DATE: 11/8/2018

APPLIES TO: This service bulletin applies to 2017 through 2019 model year, Gladiator and MetroStar Emergency Response, cabs built between 10/13/2016 and 8/16/2018.

CONDITION: Engine heating conditions may cause a breakdown with the loom associated with wiring inside the righthand side of the engine tunnel.

FIG 3.1

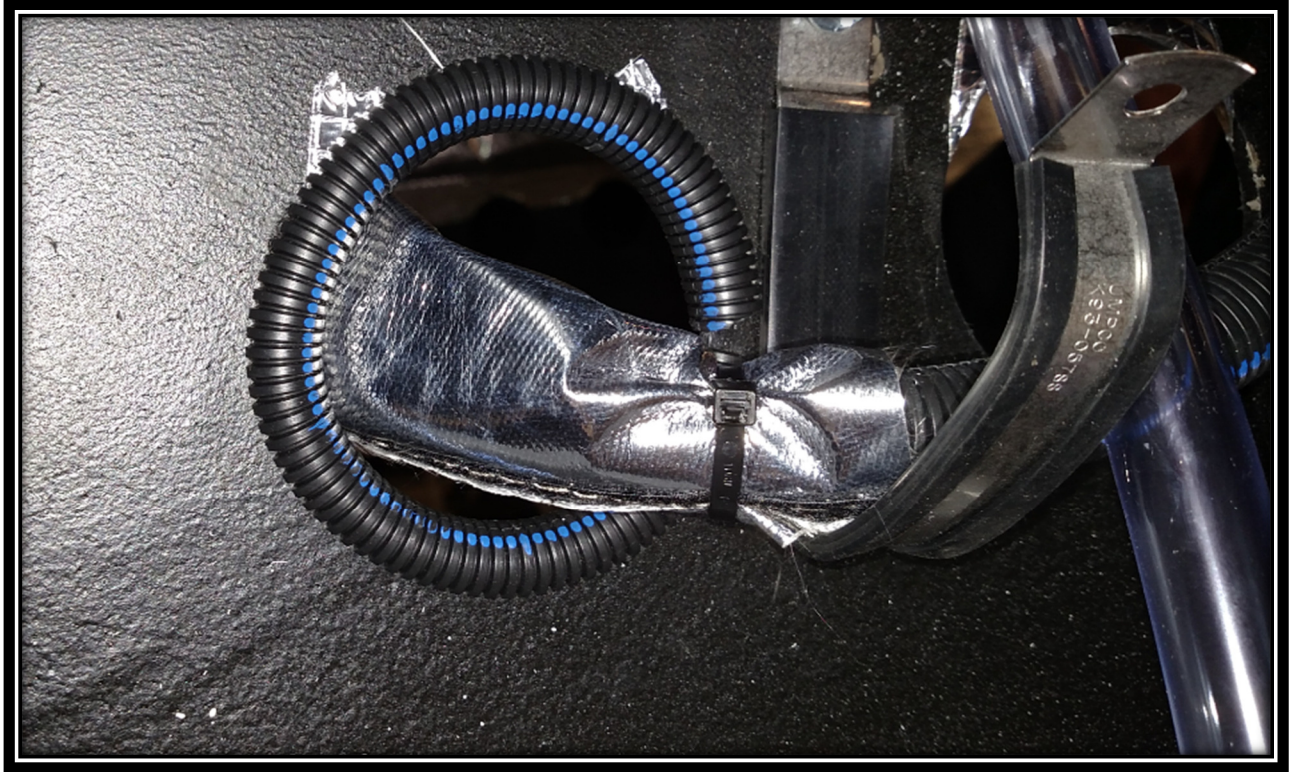
2. Heatshield needs to form around harnessing. Heatshield needs to start outside of engine tunnel as harness enters inside of tunnel. Keep approximately 6" of heatshield outside of engine tunnel. Refer to FIG. 3.1.

FIG 6.1

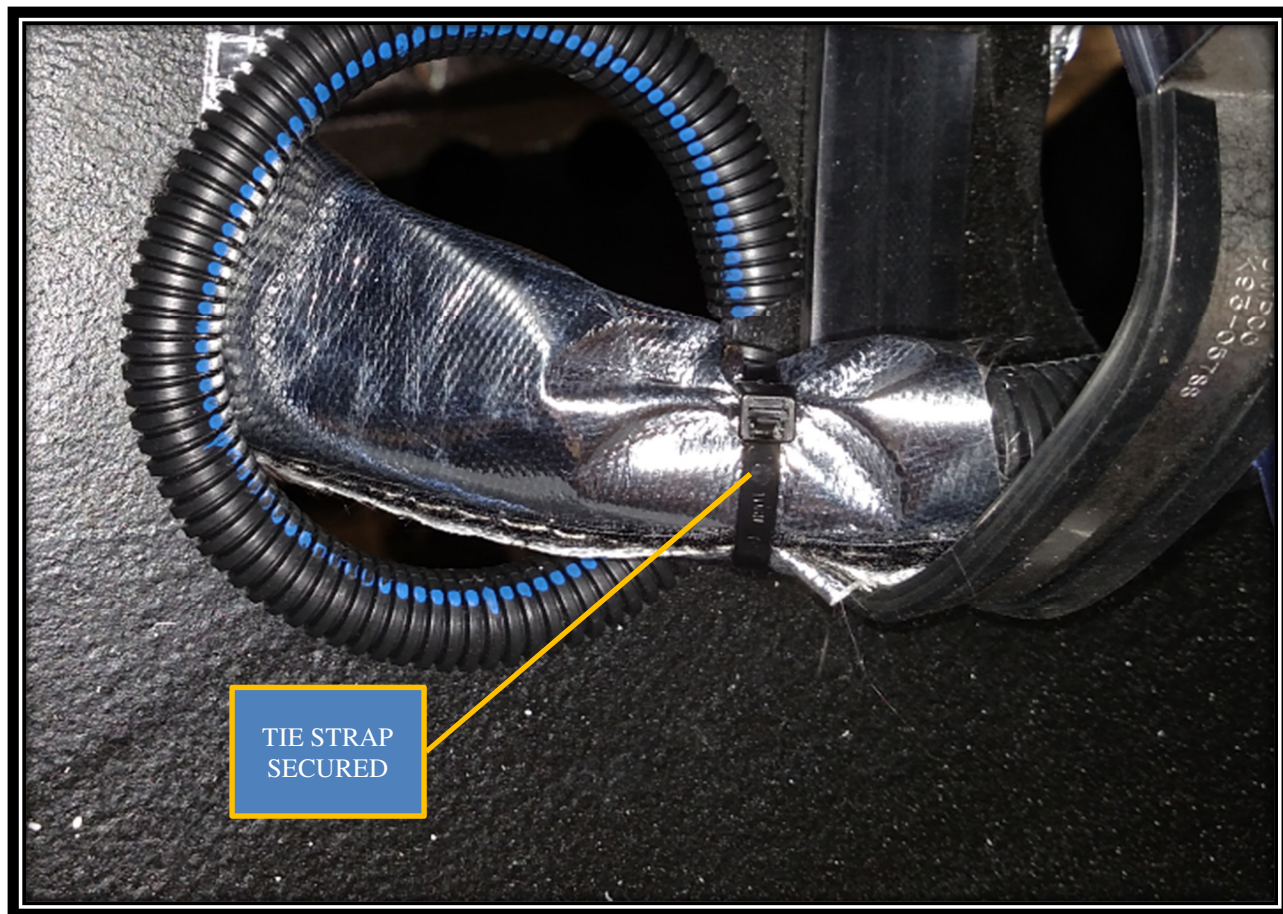
5. Each end of heatshield must be closed using a tie strap. Locate tie strap approximately 1-2" from each end of heatshield and secure. Refer to FIG. 6.1.

FIG 7.1

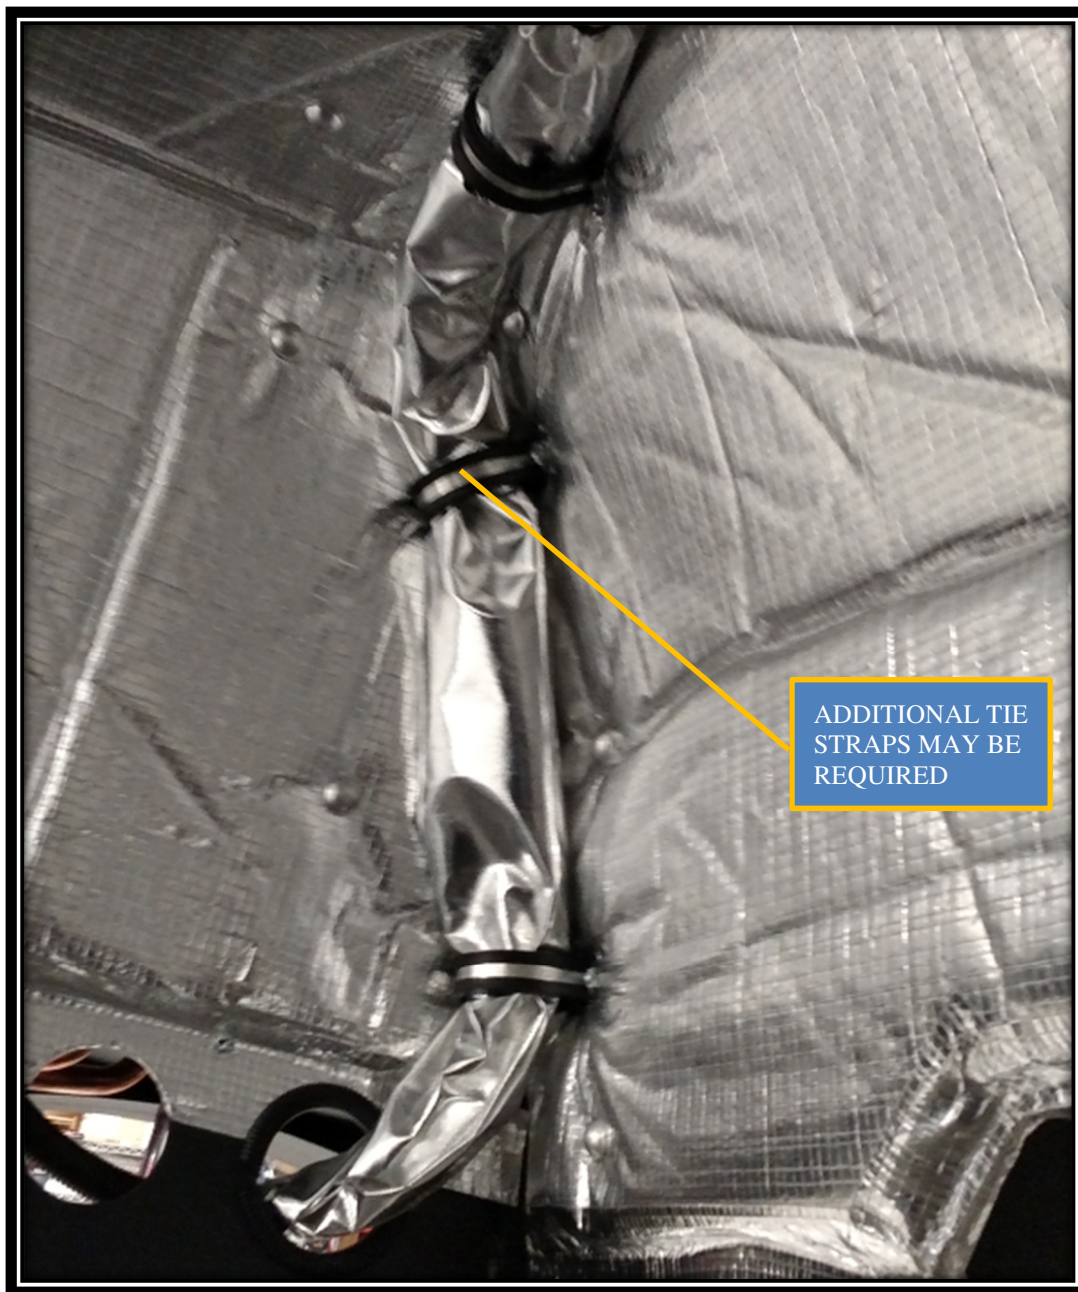
6. Typical installation shown. Additional tie straps may be used to secure smaller harnessing to loop clamps as needed Refer to FIG. 7.1.
